ROOF REPLACEMENT CAPITAL PLAZA

FRANKFORT, KENTUCKY

REVISION NO. 1 11 APR. 2005

"AS-BUILT" NOTE:

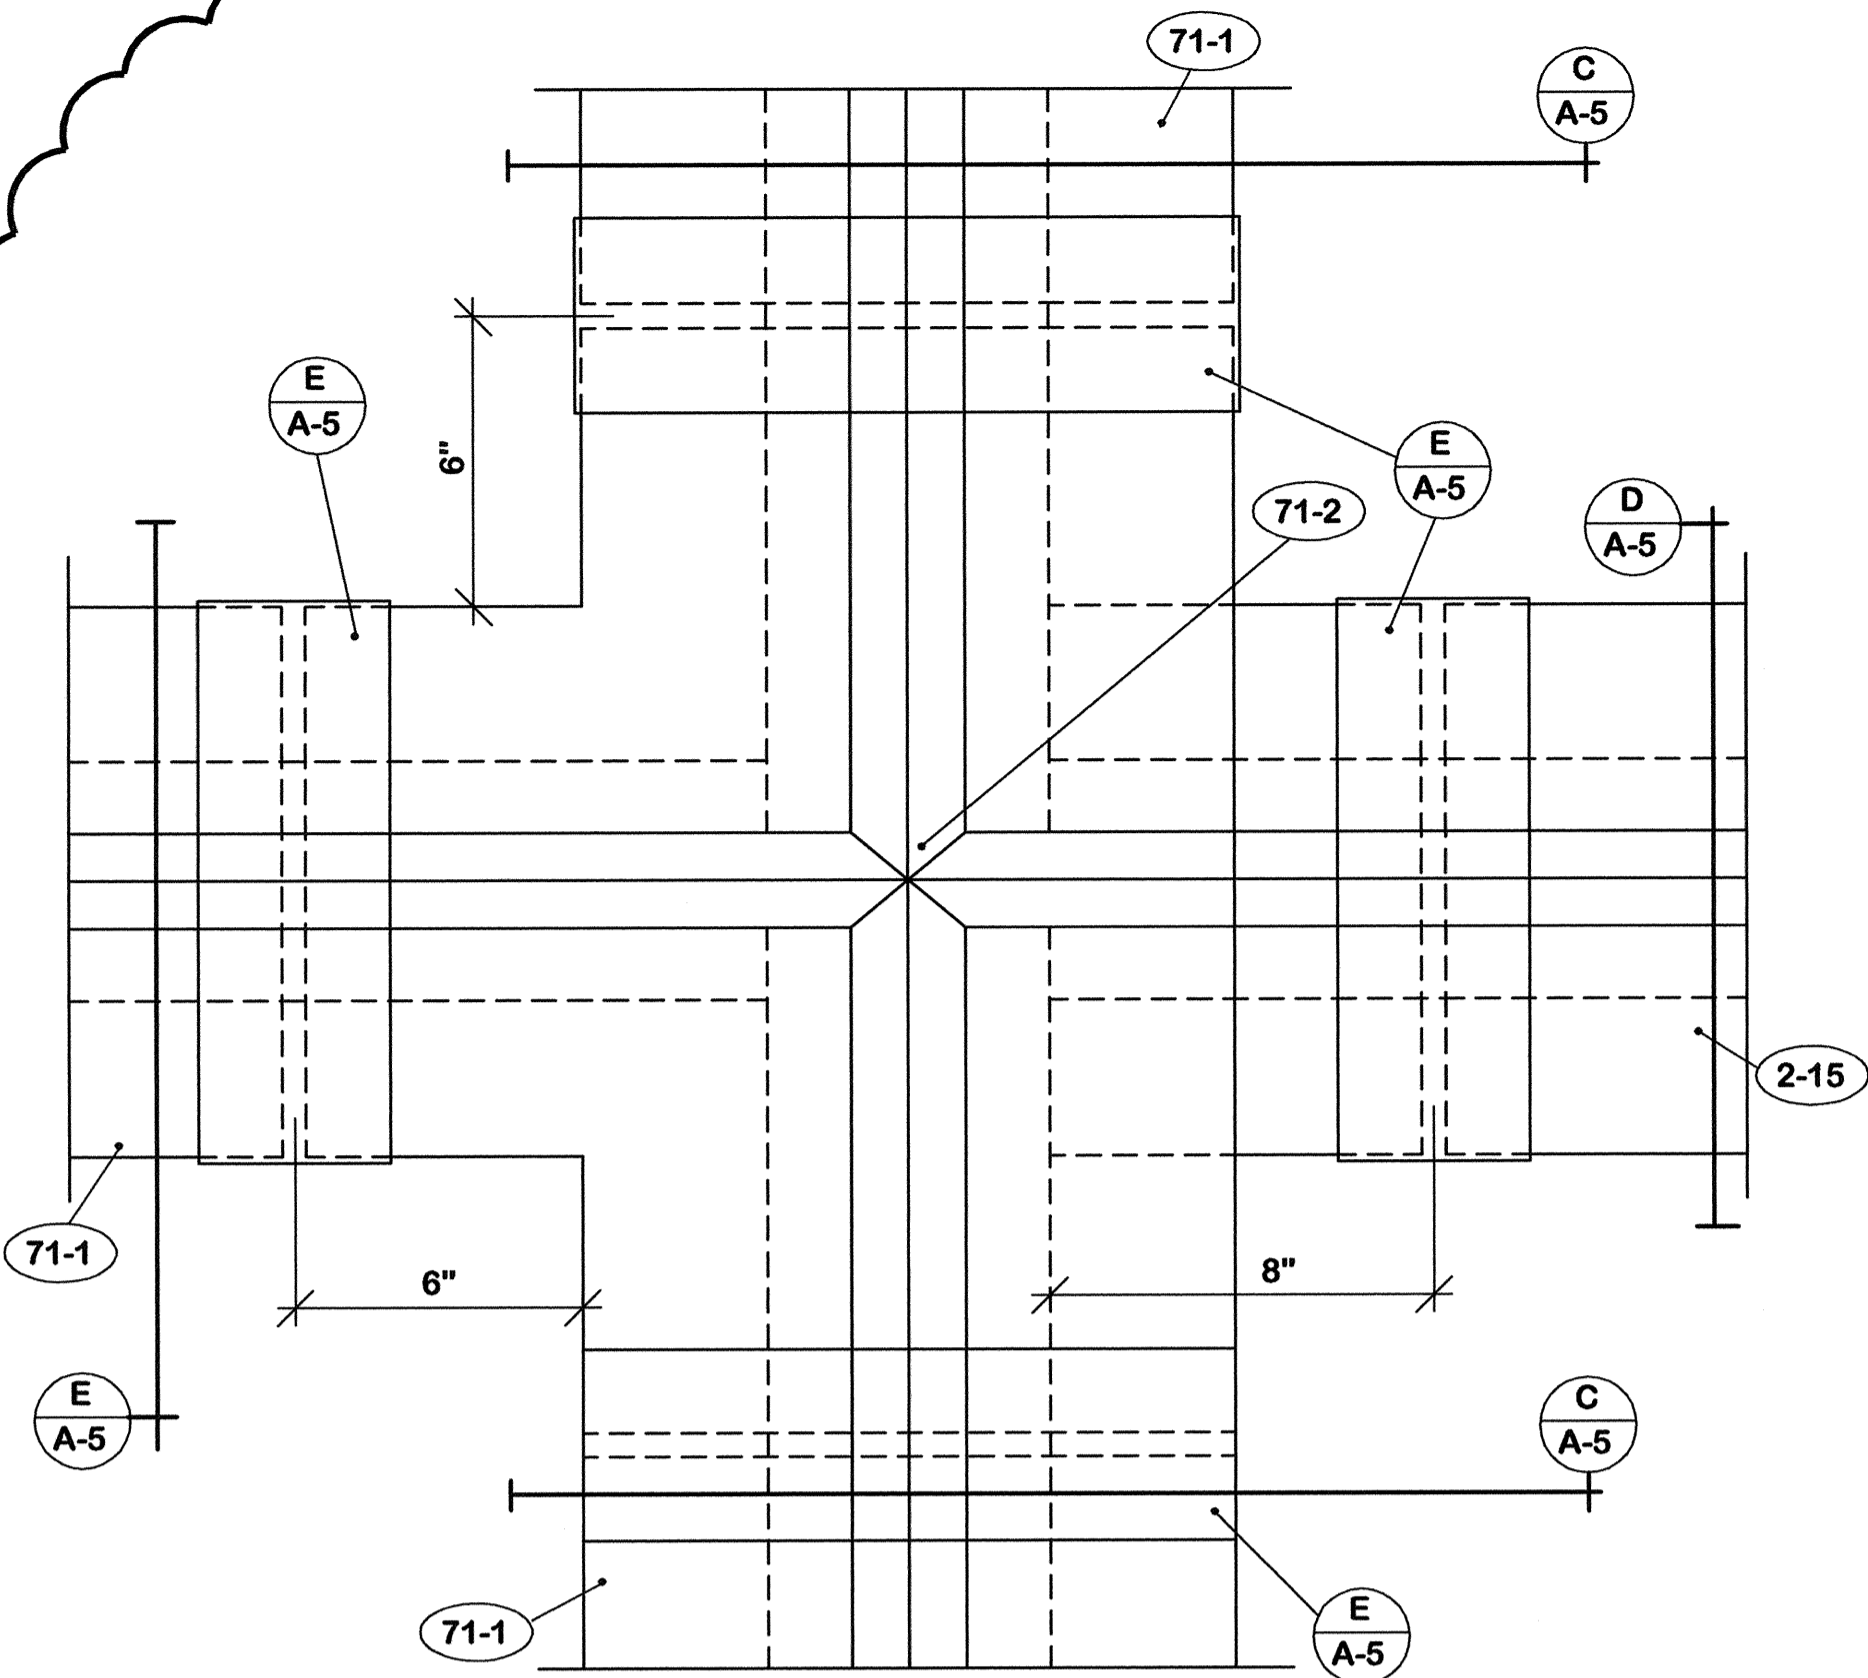
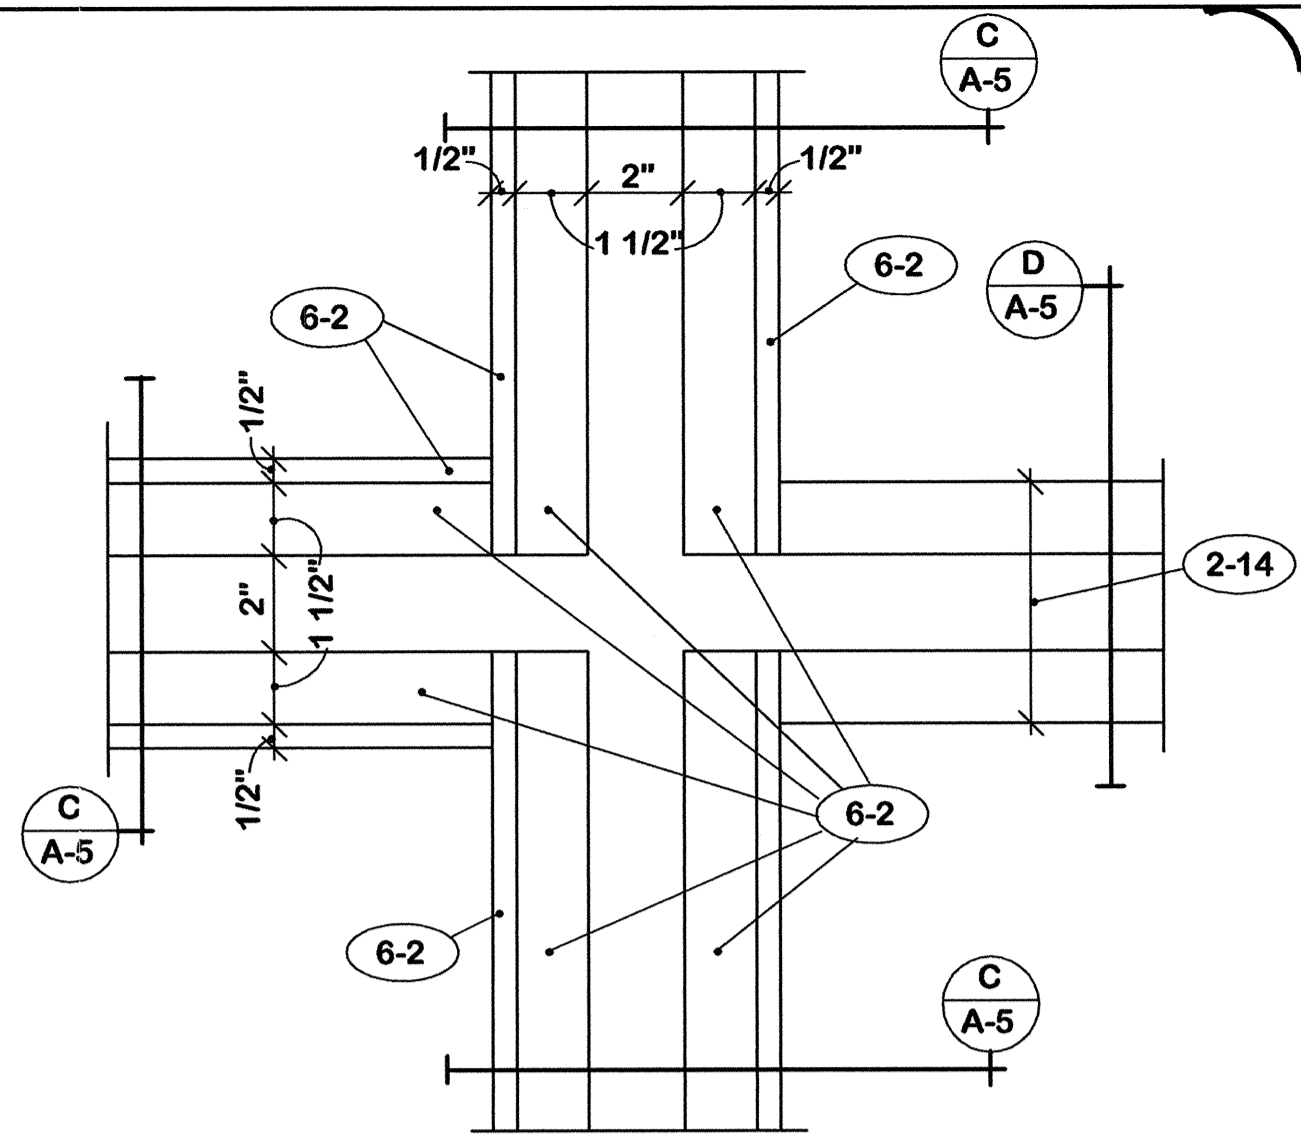
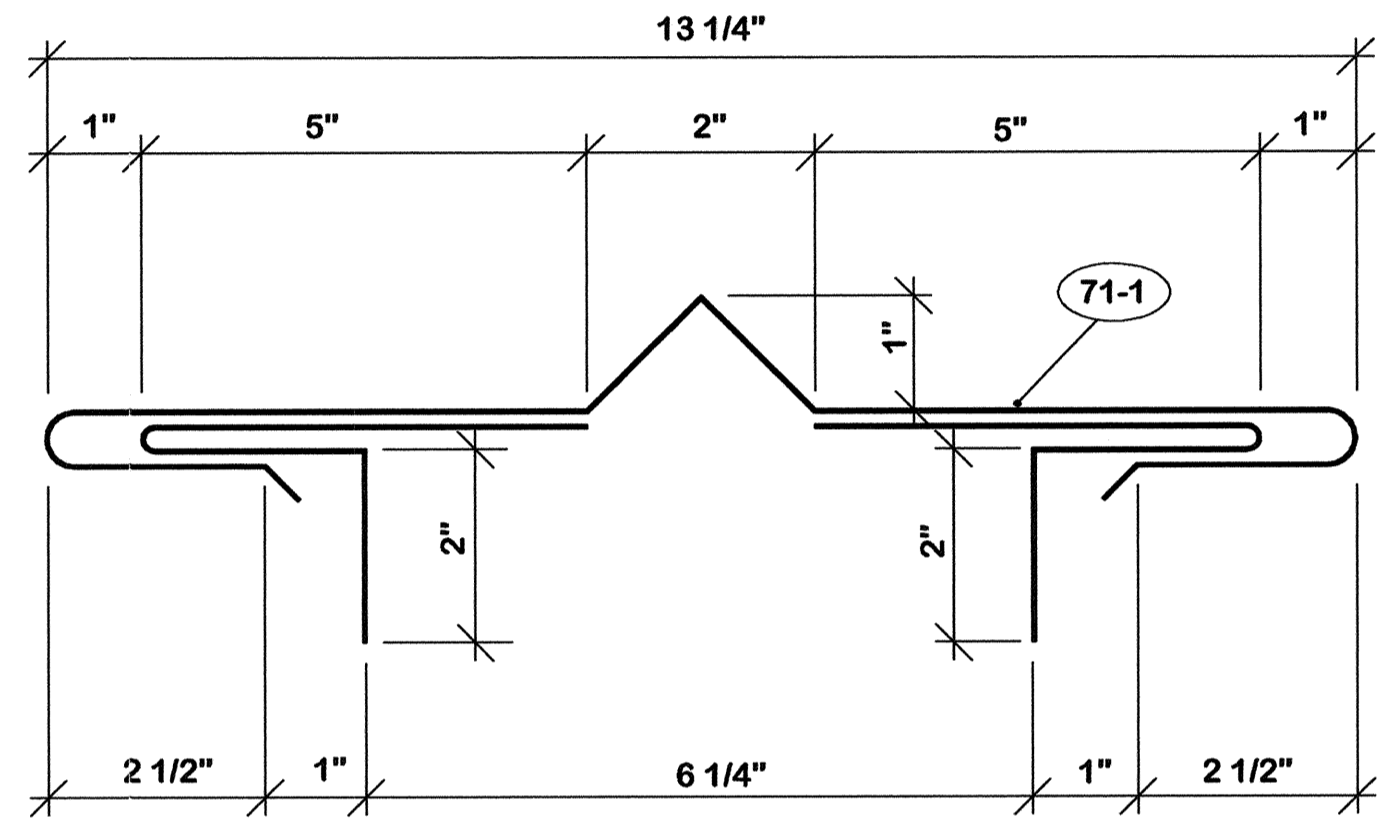
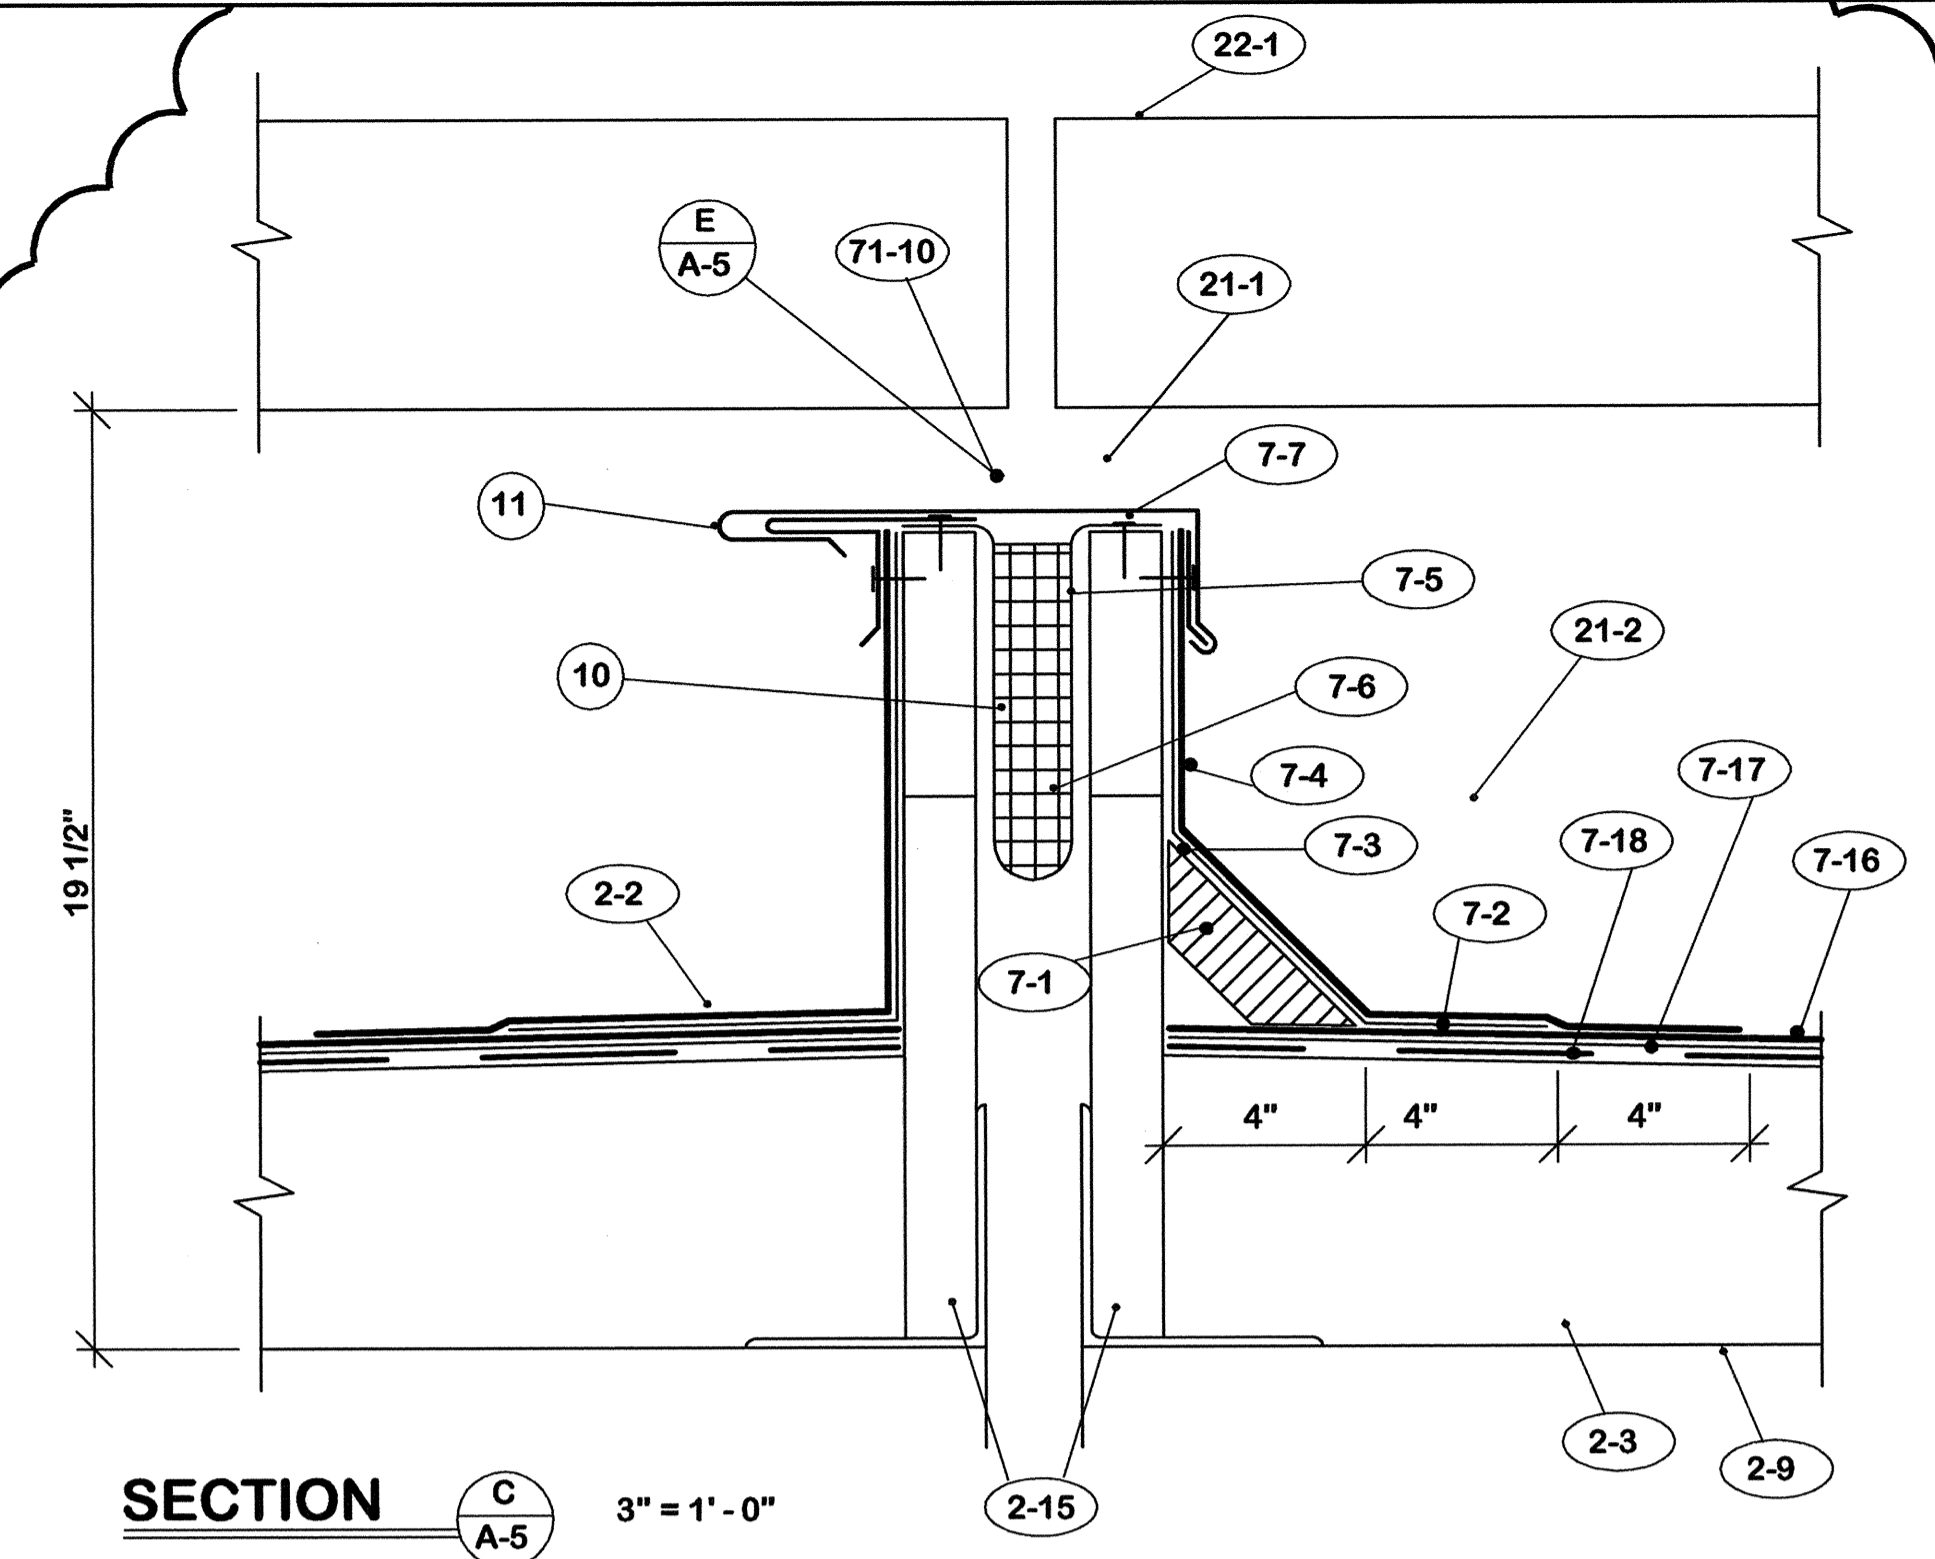
1. Delete plans A/A-5 & B/A-5.
2. Delete detail D/A-5.
3. Revise detail F/A-5.
4. Delete section F/A-5 (Z).
5. Revise section C/A-5.
6. Revise section E/A-5 (X).
7. Delete note series 6.
8. Delete notes 71-2, 71-3, 71-4, 71-5, 71-6 & 71-8.
9. Add notes 71-9 & 71-10.
10. There was not sufficient space between wood members to install insulation here.
11. This is actual profile of expansion cover originally installed.
